## COUNCIL ASSESSMENT REPORT

### SYDNEY WESTERN CITY PLANNING PANEL

<b>PANEL REFERENCE &amp; DA NUMBER</b>	DA 167.1/2023 PAN-333433 PPSSWC-337
<b>PROPOSAL</b>	Demolition of existing buildings and staged (Stages 1 and 2) construction of a mixed-use development up to 19 storeys comprising basement carparking over which will be a new market square, three buildings containing ground level retail, first level commercial including a tavern, Childcare Centre for a maximum of 80 children, two (2) medical centres and restaurant as well and 358 apartments above. The DA also seeks consent for the public domain improvement and subdivision (by boundary adjustment) to incorporate a small section of the existing cul de sac head at the end of the public lane.
<b>ADDRESS</b>	<ul style="list-style-type: none"> <li>- Lot: 7 Sec: E DP: 4420 No. 76 Broomfield Street, Cabramatta</li> <li>- Lot: 1 DP: 205759 and Lot: 10 DP: 255023 No. 84 Broomfield Street, Cabramatta</li> <li>- Lot: 2 DP: 205759 No. No. 86 Broomfield Street, Cabramatta</li> <li>- Lot: 2 DP: 580587 No. 139 Cabramatta Road East, Cabramatta</li> <li>- Lot: 8 DP: 25618 Nos. 147 – 149 Cabramatta Road East, Cabramatta</li> <li>- Lot: 5 DP: 2

**Figure 41:** Level 3 and Level 9 of Building C and the distance to the isolated sites along Cabramatta Road East and Broomfield Street.

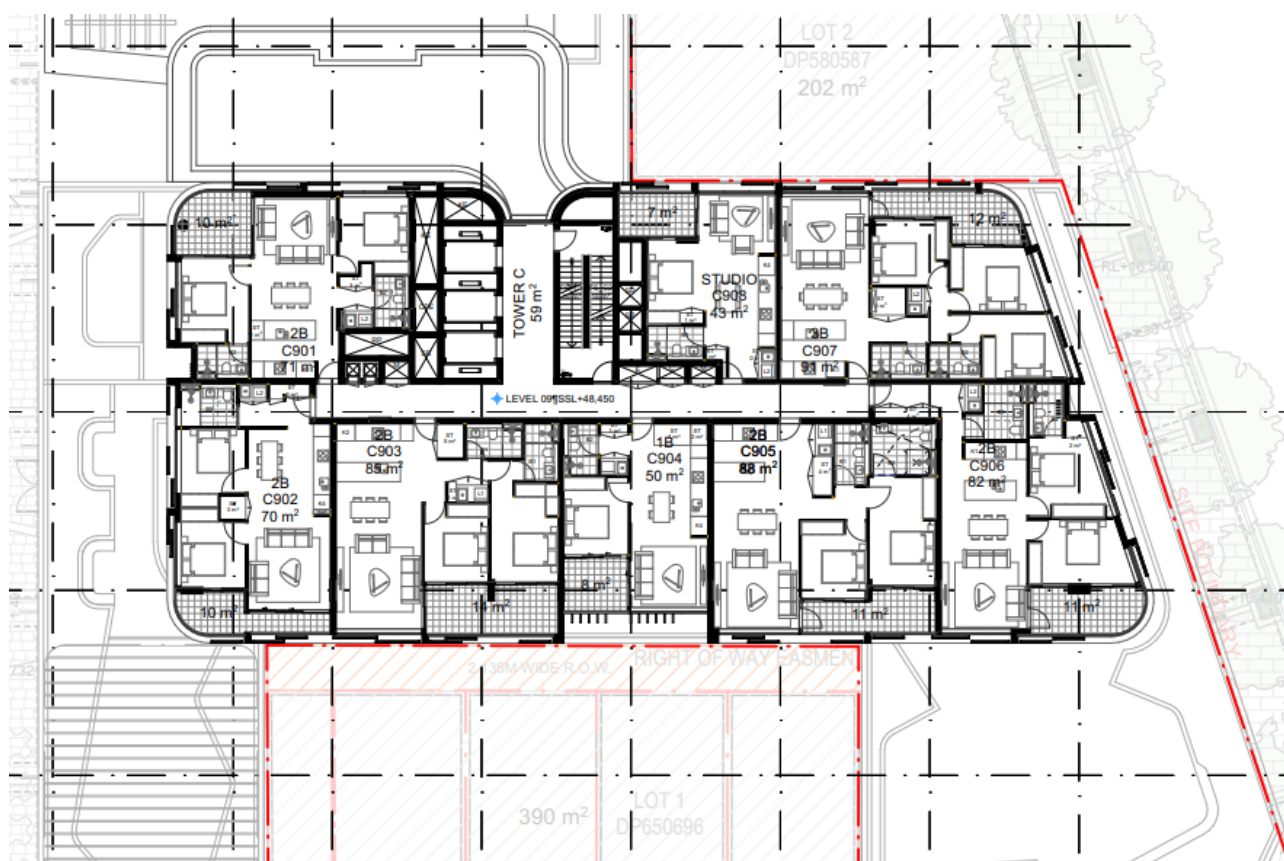
1. Figure 5 (page 8) is labelled '**Level 3 layout (indicative of all residential levels except topmost)**'. Please note that this is not correct as by reference to the submitted DA plans, Tower C floor area increases in size from Level 4 and which results in reduced building setbacks from the boundaries of isolated site A (88-92 Broomfield Street) and site B (143-145 Cabramatta Road).

Accordingly, at Level 4 and above of Building C, the proposed design will not comply with BCA deemed to satisfy provisions for habitable rooms in a class 2 building, as many windows are proposed to be located approximately 0.4m from the side boundary with isolated sites. This is further discussed within the report. Given the breach in the BCA and that it would require significant amendments to the design in order to meet compliance, Council's Building Control (Certification) Branch do not support the application.

**Figure 42:** Five (5) lots not included in the Application that are within Stage 2.

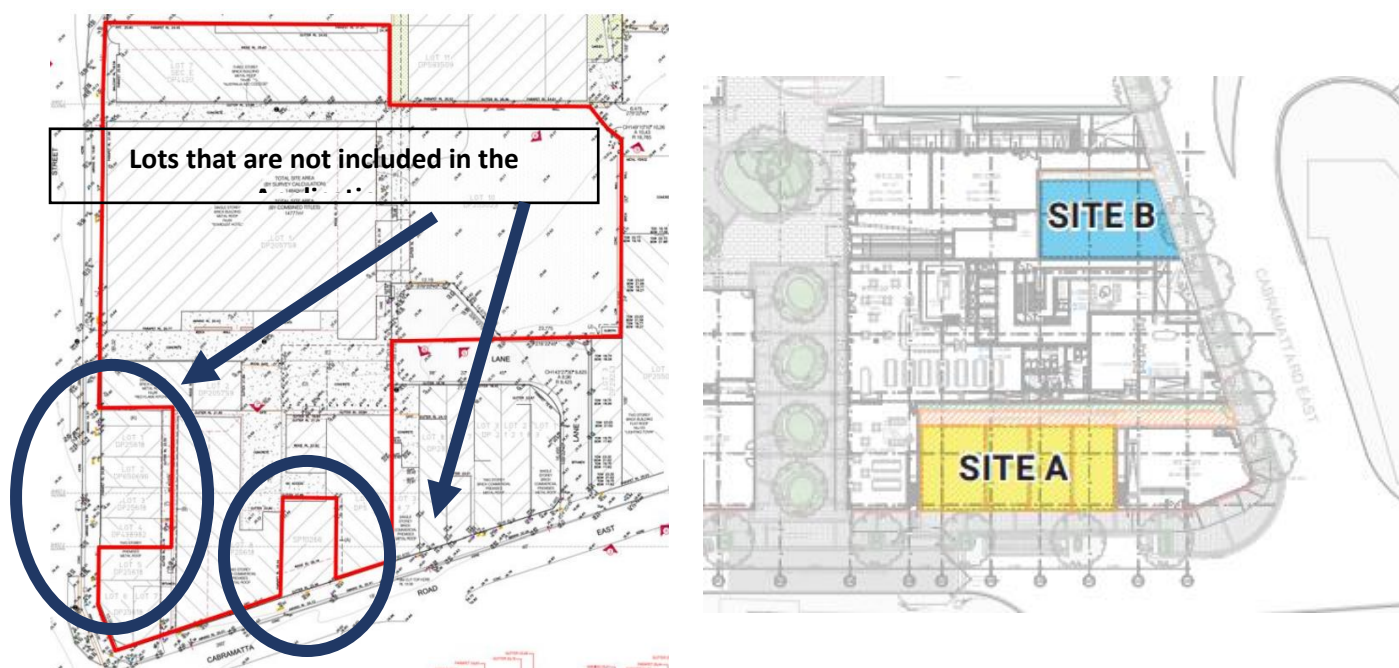
These lots were included in the master planning for the precinct and do not currently form part of the Proposal. It is noted that the Panel in its record of its site visit, advised that it was particularly concerned about the implications of not integrating the Broomfield St properties on the overall urban design outcome of the redevelopment of Broomfield St. Furthermore, Council advised in two (2) previous Pre DA meetings, concerns in regards to developing Stage 2 in the absence of these lots.

**Figure 43:** Ground, Level 1, Level 3, Level 4 and the southern elevation of Building C and its location adjacent to the isolated lots.

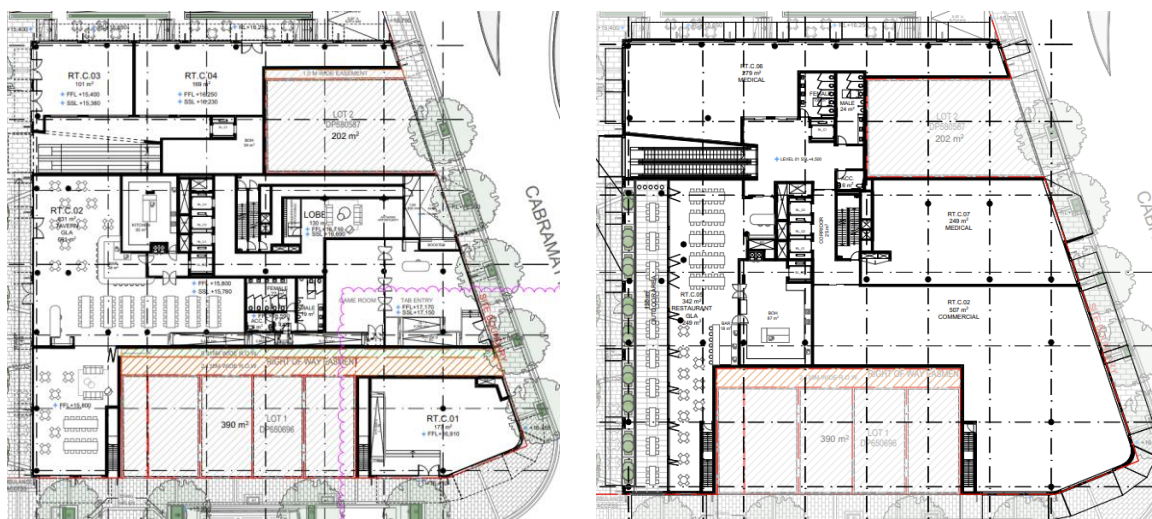
As discussed earlier in this report, the proposed development does not include four (4) lots that front Broomfield Street and one (1) lot that faces Cabramatta Road East as part of Stage 2. In addition to this, the proposed development seeks a 19 storey mixed building (Building C) that is located directly adjoining the isolated lots as described in the Figures below:

Building C will be built to the boundary of both isolated lots for the ground level and the first floor. The building will then be setback on levels 3 and 4 (the communal open space located on level 2) will be up to the boundary. From level 4 to 18 Building C is built to the boundary of the isolated lots. It is also noted that the isolated lots on Broomfield Street have a Right of Way (ROW) located within the rear of these lots. The proposed development will maintain the

**Figure 44:** Develop the existing 2 storey commercial isolated site along Broomfield Street to a 3 storey Mixed use building.

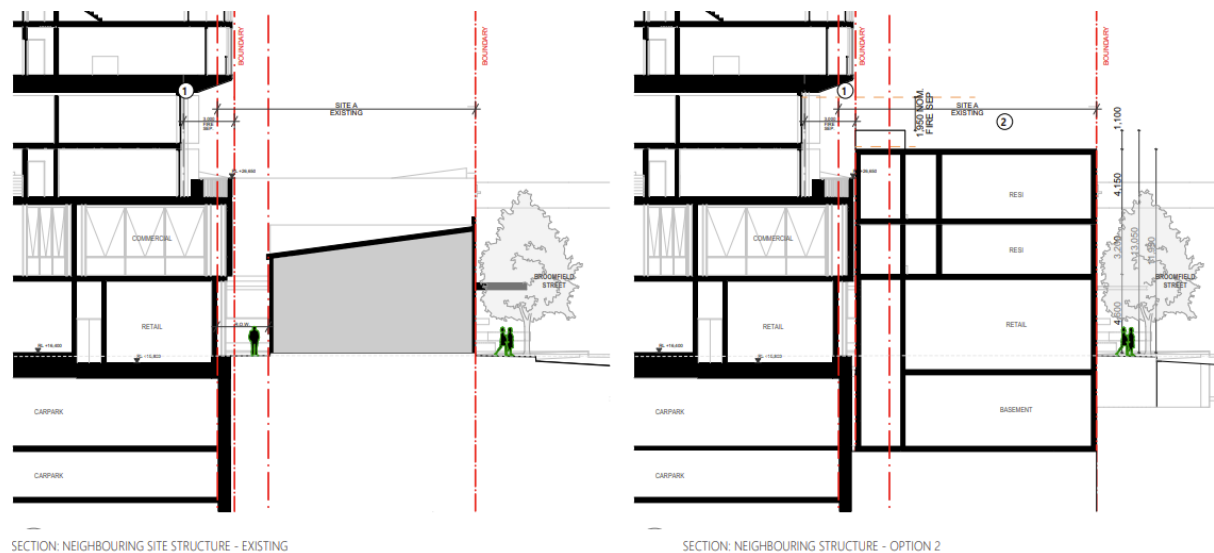
In response to this, further documentation was submitted to support this arrangement. In the architectural response, built forms were provided that showed how these sites could be developed. This is shown in the figures below:

Figure 48: SSDCP layout of Building A and Stage 3 and the proposed arrangement for Building A.

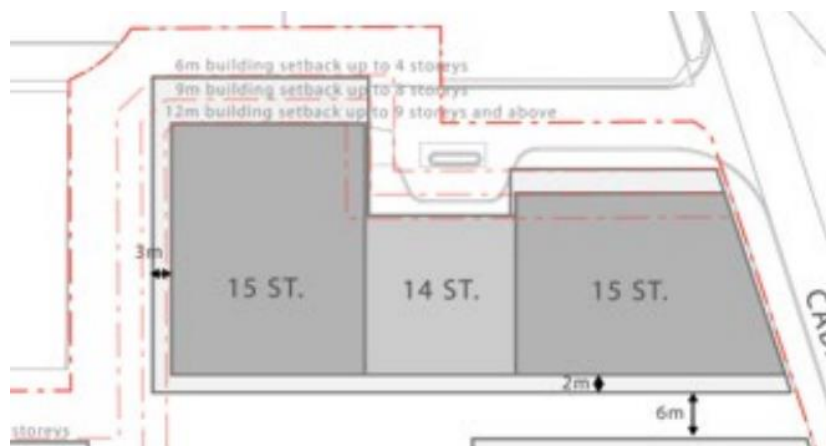
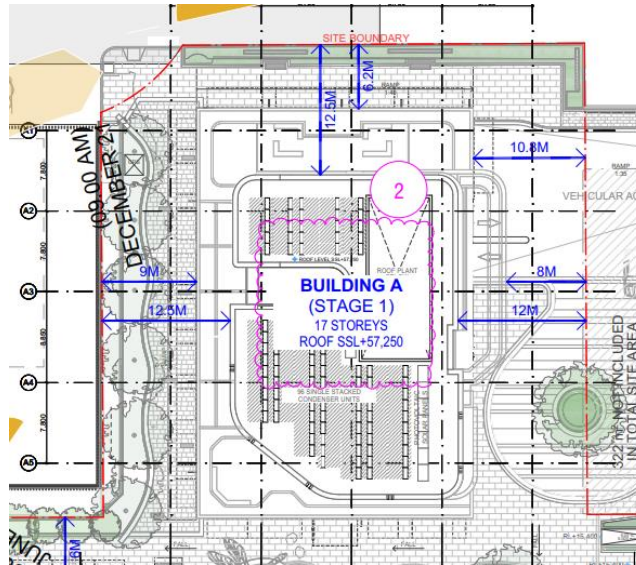
Building A is designed as an 18 – storey building whilst the SSDCP allows only a 15 – storey building. The building is also designed in a way that would not allow for a 14 storey building that connects with Stage 3. The proposal also relies on the acquisition of part of Council’s laneway in order to provide vehicle access to the future Stage 3 development. The laneway has not been acquired at this stage. In addition, it is noted that the southern elevation of Building A contains balconies and habitable space and therefore is likely to have adverse design implications for any future development within Stage 3. This is described in the figures below:

In response to this concern, documentation has been submitted, to demonstrate that Stage 3 could be developed, however, in a manner that is inconsistent with the SSDCP built form layout. Given this, concern is raised that the proposed development would impact the ability of Stage 3 to develop in a manner that is consistent with the SSDCP.

Figure 49: SSDCP layout of Building B and Stage 4 and the proposed arrangement for Building A.

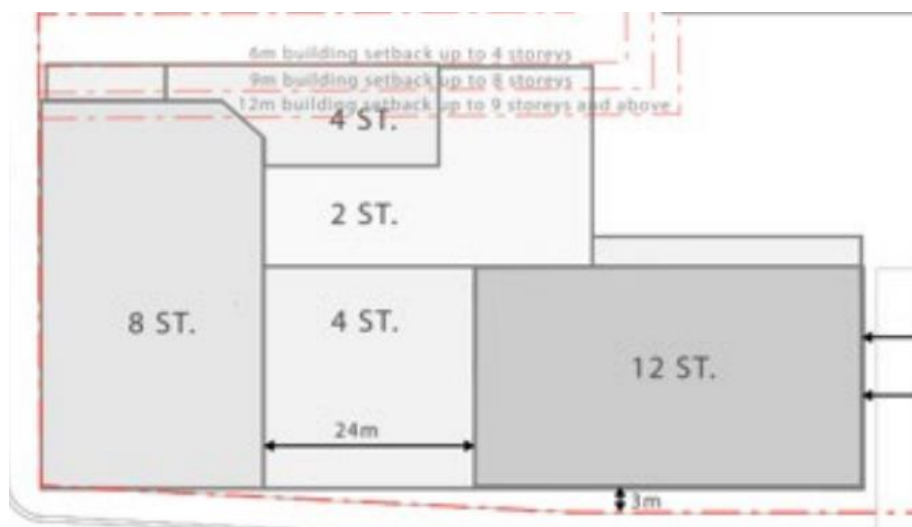
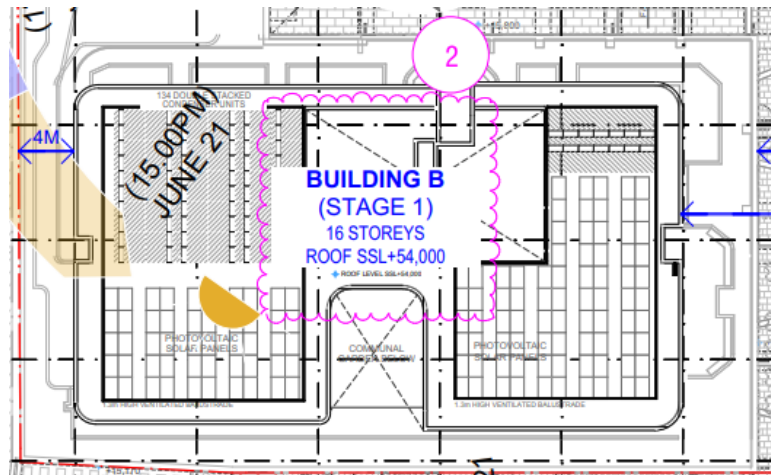
Building B is designed as a 16 – storey building whilst the SSDCP allows only for a 12 storey building. The building is also designed in a way that would not allow a connection to a part 2 and 4 storey building in Stage 4. Furthermore, it is designed with openings and units facing the northern boundary of the site with only a 4m setback and therefore would not comply with the building setbacks required by the Apartment Design Guidelines. Lastly, It is also noted that there are openings directly along the northern boundary of level 1 which would not comply with the Apartment Design Guidelines and fire separation requirements of the BCA. This is considered to be unacceptable. This is indicated in the figures below:

Figure 50: There are openings on the Northern boundary of level 1 and openings/habitable areas within 4m of the northern boundary for Building B.

Part of the Applicant's response to this matter is contained in the Amended Architectural Report pages 11 and 12, which indicate that the development in Stage 4 *"The final building heights on Stage 4 will obviously marry with the blank wall built to boundary of the proposed development (Building B) in Stage 1 and noting that this will cap the maximum height in this part of the Stage 4."* The amended Architectural response then provides an alternative layout to the DCP which is as follows:

Figure 52: SSDCP layout of Building C and the proposed arrangement for Building C with opening/balconies directly adjacent to the isolated sites.

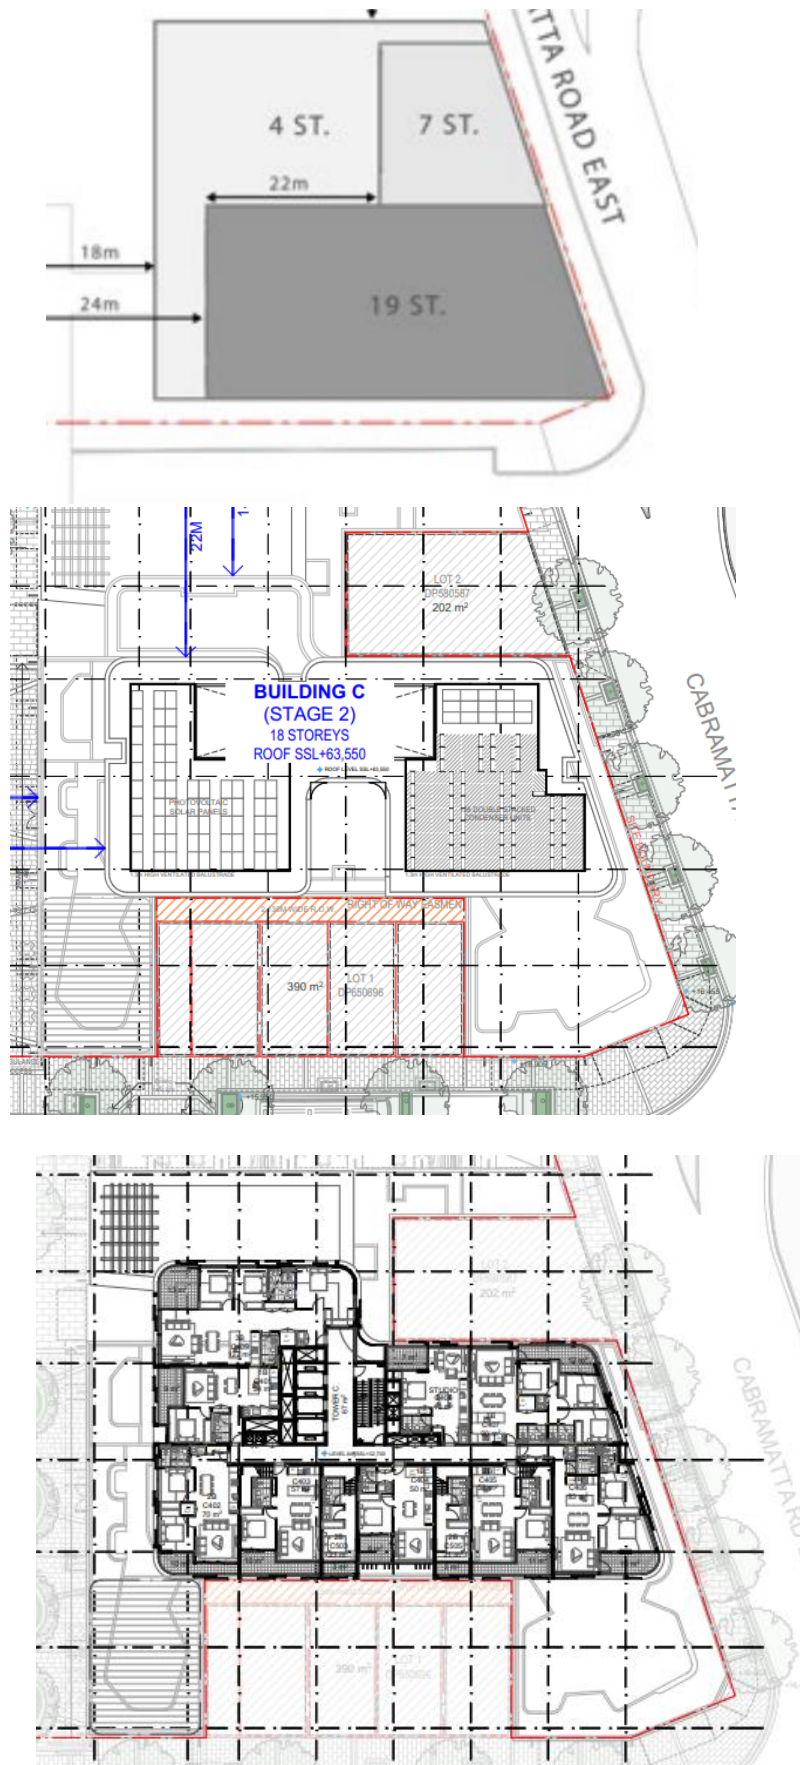
As discussed above, from levels 4 and up, Building C will have balconies and fire source features directly abutting the boundary with the excluded lots. The Applicant's response to this is to demonstrate that a mixed commercial/residential building within 14m building height could be built on the isolated sites and provides vehicle access within the basement. It is noted that this approach does not consider other design options nor contemplate other applicable legislation such as the recently amended State Environmental Planning Policy (Housing) 2021, which allows an additional 30% height in certain circumstances. The BCA report and Fire safety report submitted also do not consider the fire source features on the boundary from levels 4 and up. Given this, it is considered that the proposal would likely prejudice the development potential of the adjoining excluded lots.
